Discuss and take appropriate action on Change Order #6 for Williamson County Regional Park.

RE: Williamson County Regional Park

Change Order #6

RFI No. 66

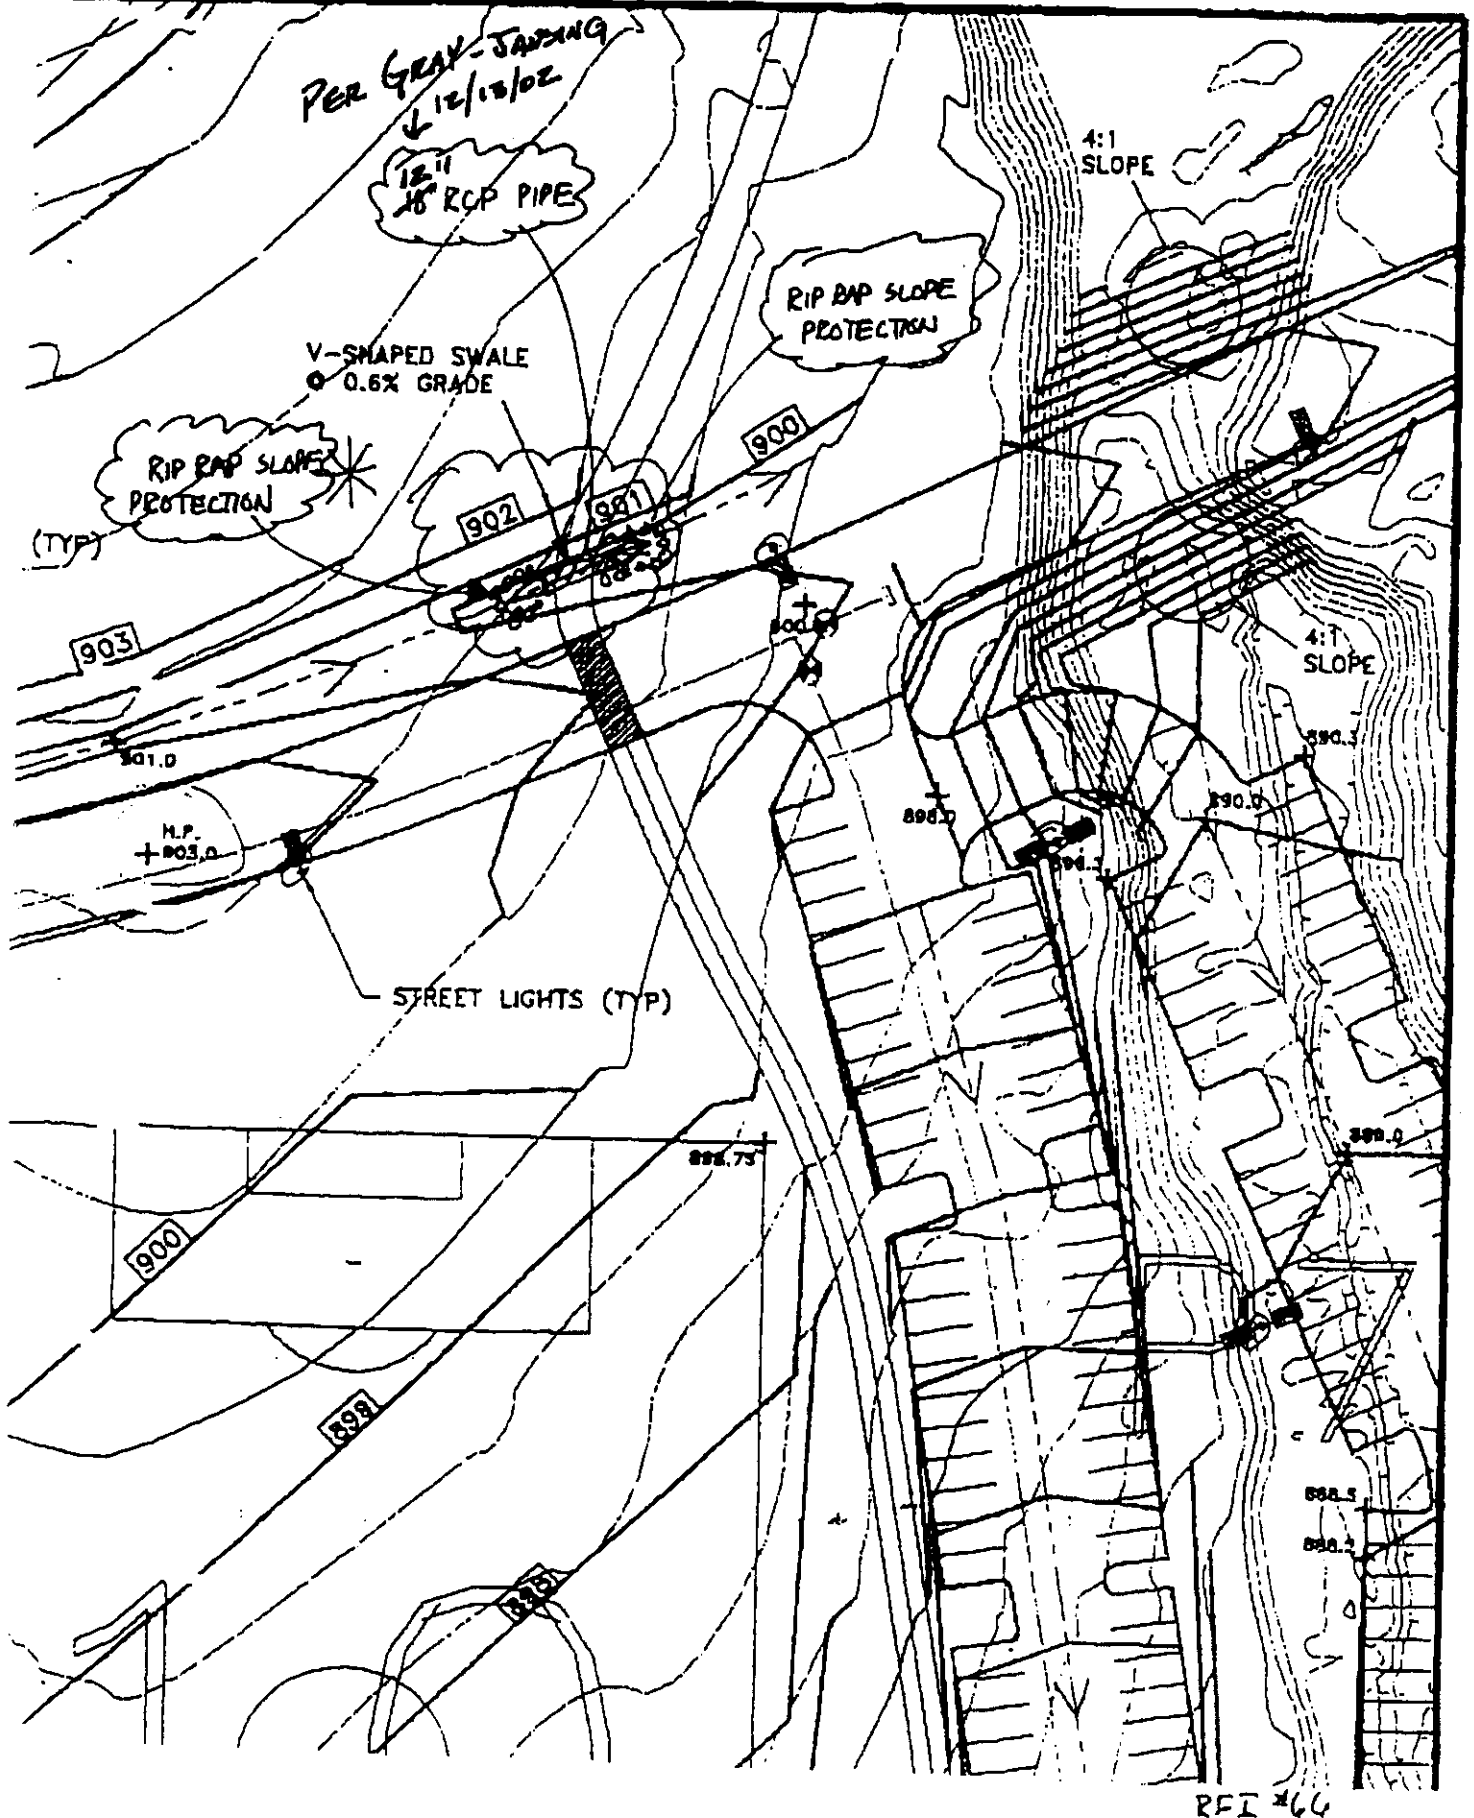
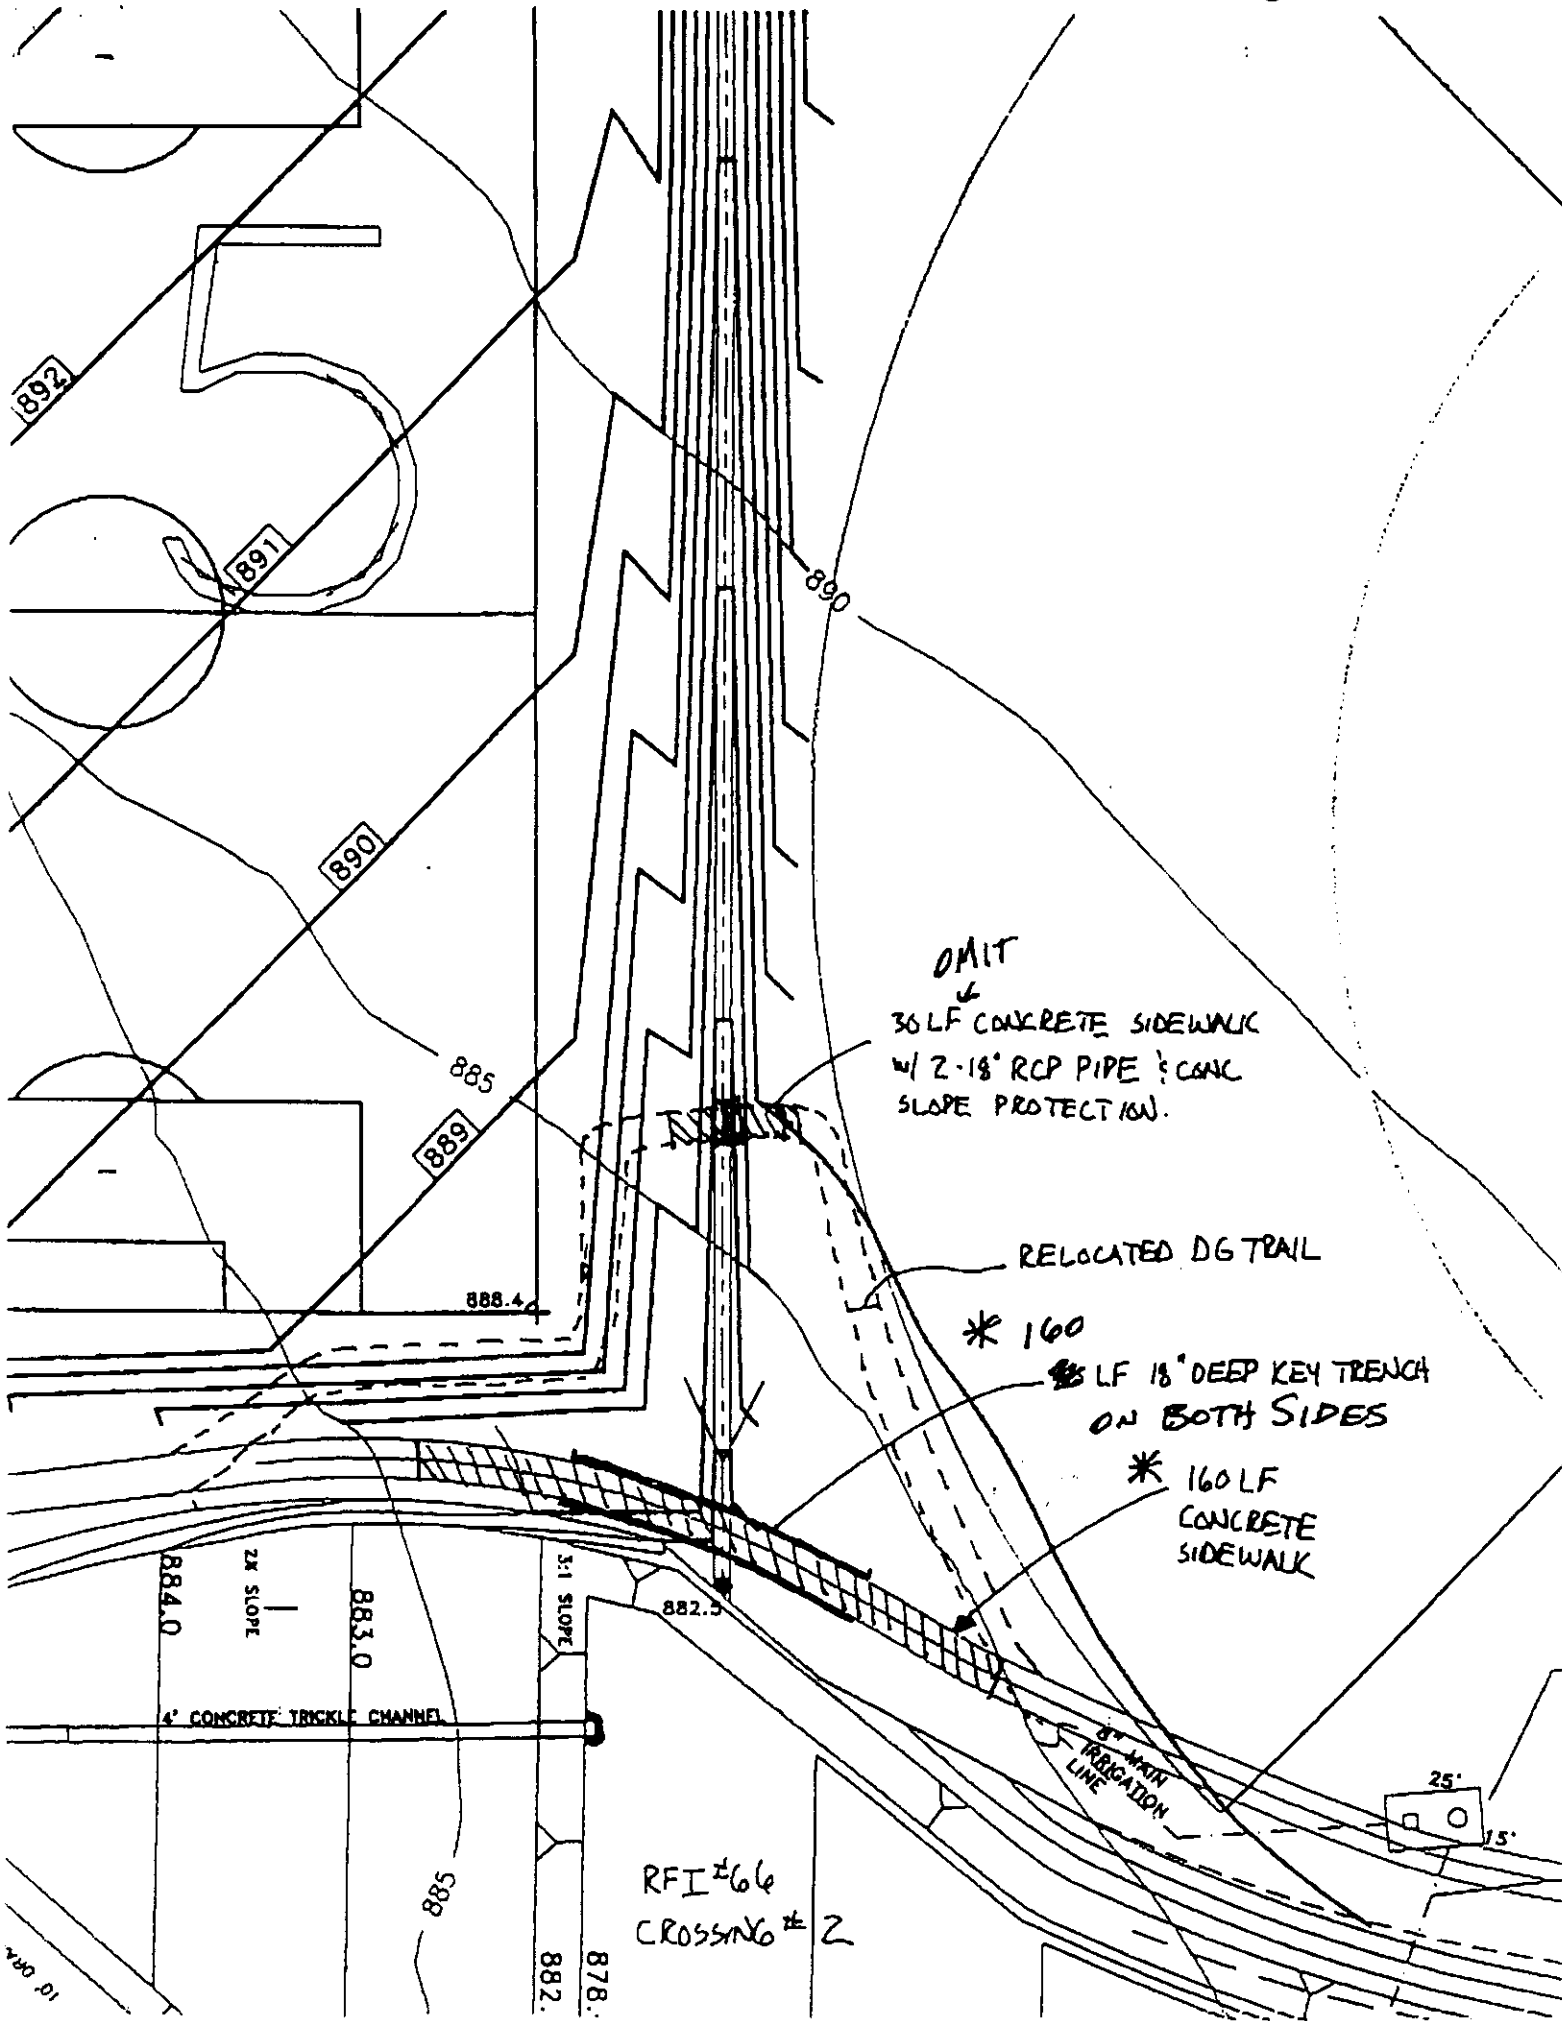
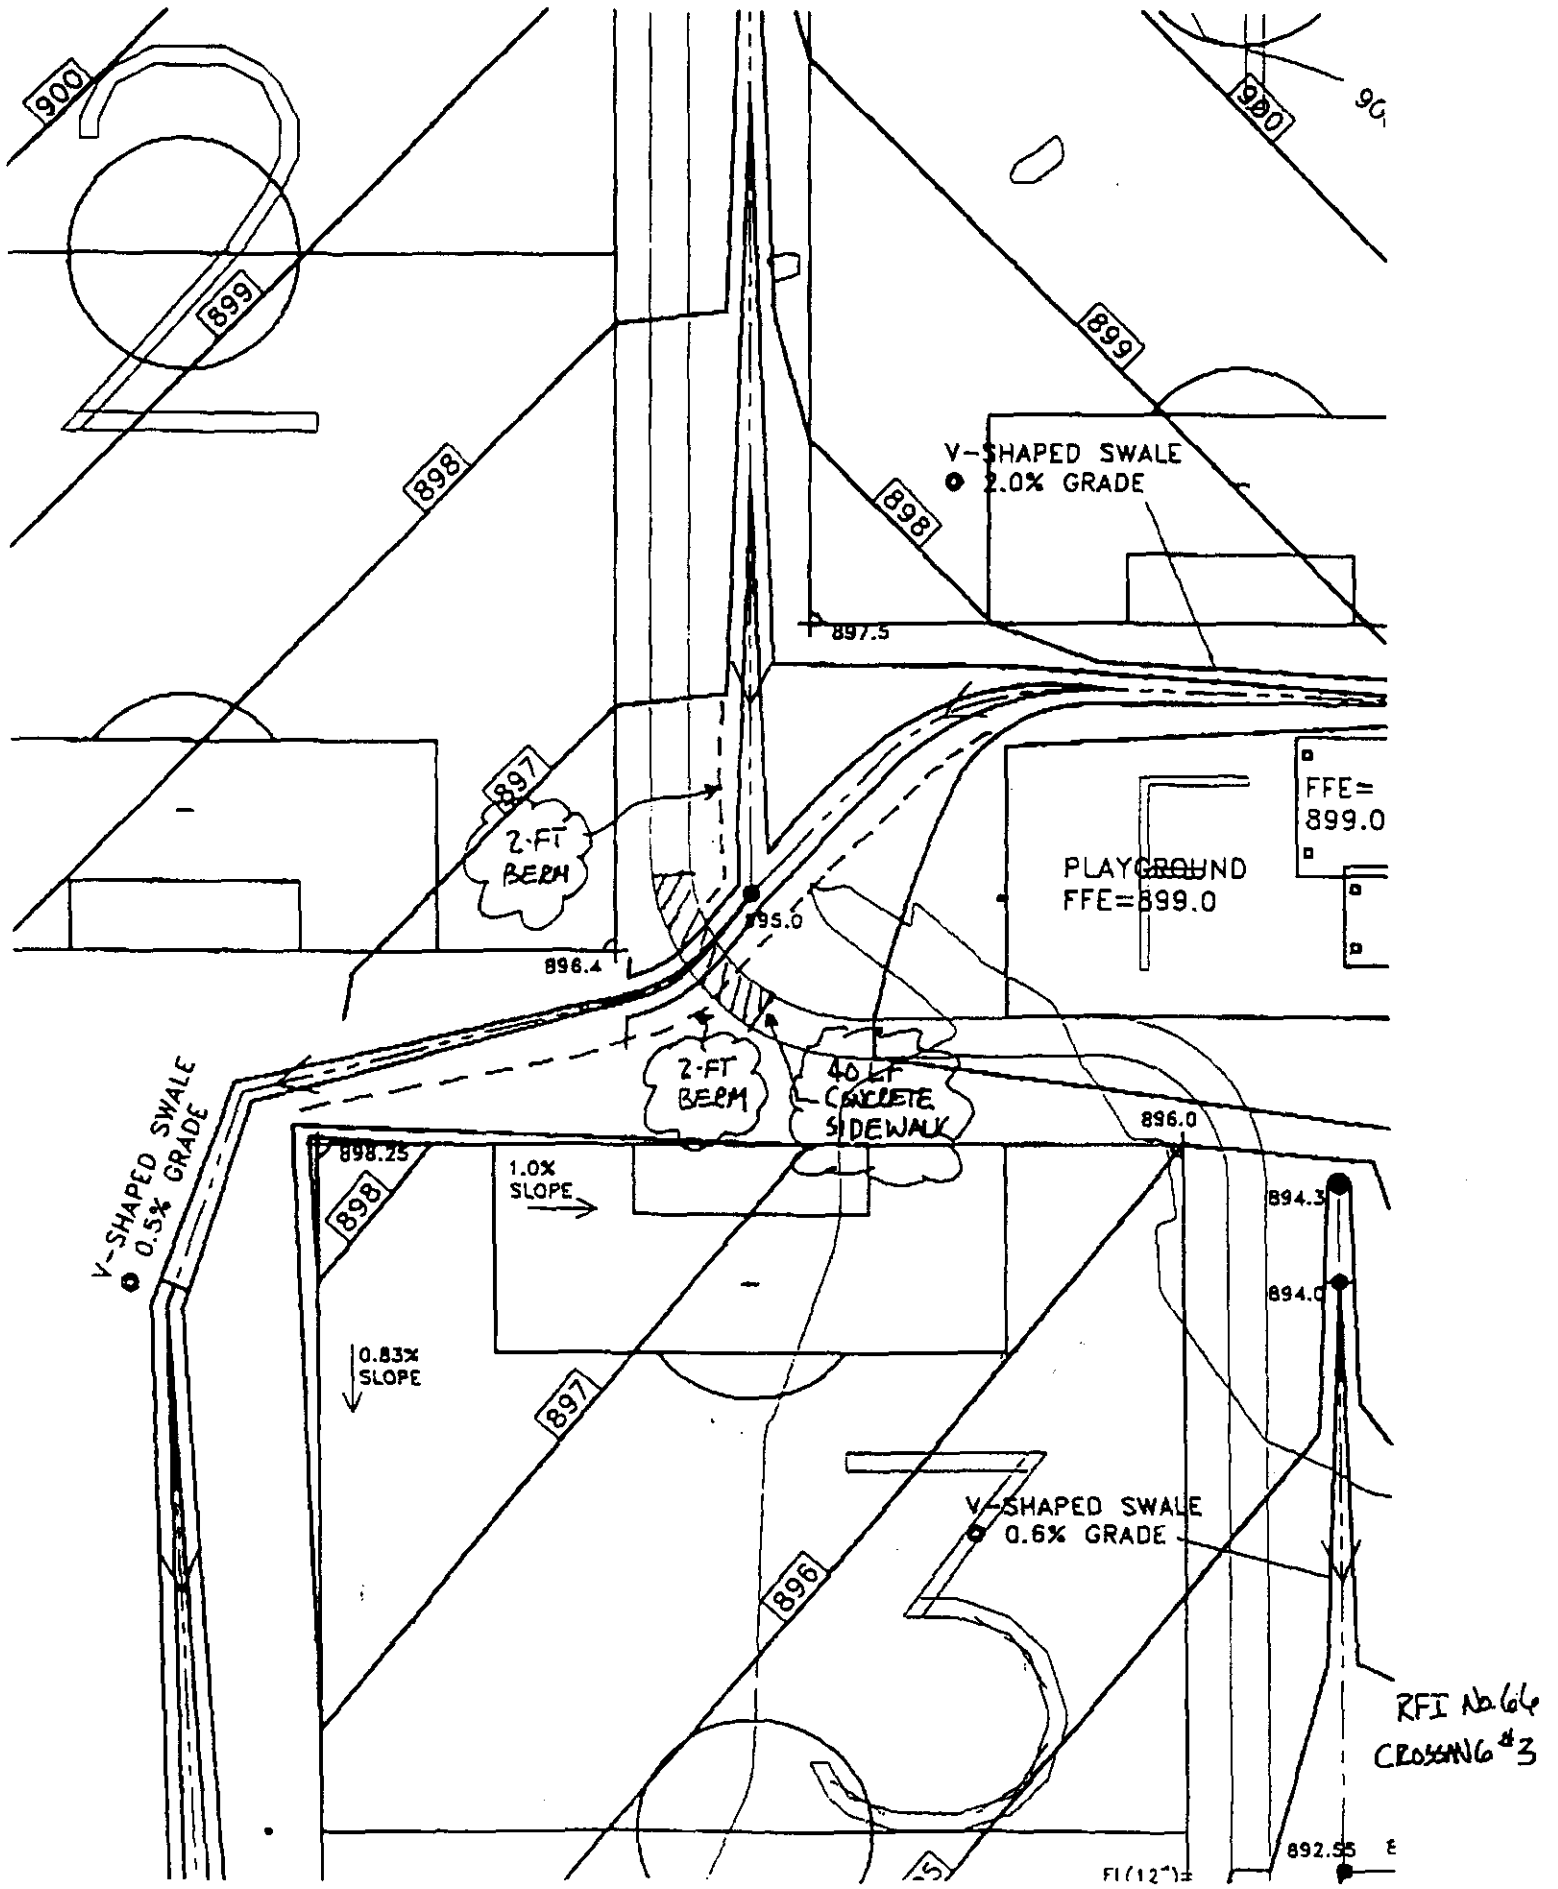
We have reviewed the RFI request for additional information on the decomposed granite trail crossing of the drainage channels at three locations. After reviewing the existing site conditions, the following are our recommendations.

After the drainage swale has been cut and graded, install an 18-inch diameter RCP or CMP pipe where the trail crosses the swale. Backfill around the pipe with clay material. Place concrete riprap material on the upstream and downstream faces of the pipe to protect from erosion around the pipe. Trail may need to be raised to accommodate the pipe and to provide adequate cover over the pipe. Use of HDPE or PVC pipe for this crossing will not be allowed.

After crossing the drainage channel, the trail would then turn south and follow around the south end of the future baseball field and following the 885 elevation line to stay out of the possible inundation area of the detention pond.

Option 2: Construct the trail along its designated path as a concrete sidewalk for the portion that extends across the potential inundation area (below Elev 885). This would be for a distance of 80-feet on either side of the drainage swale centerline. The sidewalk elevation should match the drainage channel flowline where it crosses the 4-foot bottom width of the channel. An 18-inch deep toe should be installed on the upstream side of the sidewalk for a distance of 40-feet on either side of the drainage swale centerline to prevent the sidewalk from being eroded during times of water flow.

Crossing #3: North end of Soccer Field #3, SE corner of Soccer Field #2

* At this location, there are no well defined banks on the two drainage swales that converge at this location. The granite trail crosses downstream of this convergence point. Following final grading of the drainage swales, if the banks are not well defined, and additional fill is not brought in to elevate the areas, it is recommended that the trail be constructed as a concrete sidewalk for the section that crosses the drainage area. This would be for a distance of 20-feet on both sides of the drainage swale centerline. The upstream face of the sidewalk should have a 12-inch deep toe on the upstream side of the trail for the entire length of the concrete sidewalk. If additional fill is not placed to define the drainage swales upstream of the trail crossing, landscape berms with a minimum height of 2 feet should be placed parallel to the drainage swale centerlines to contain the drainage flows. The sidewalk/trail would pass over the top of these berms.
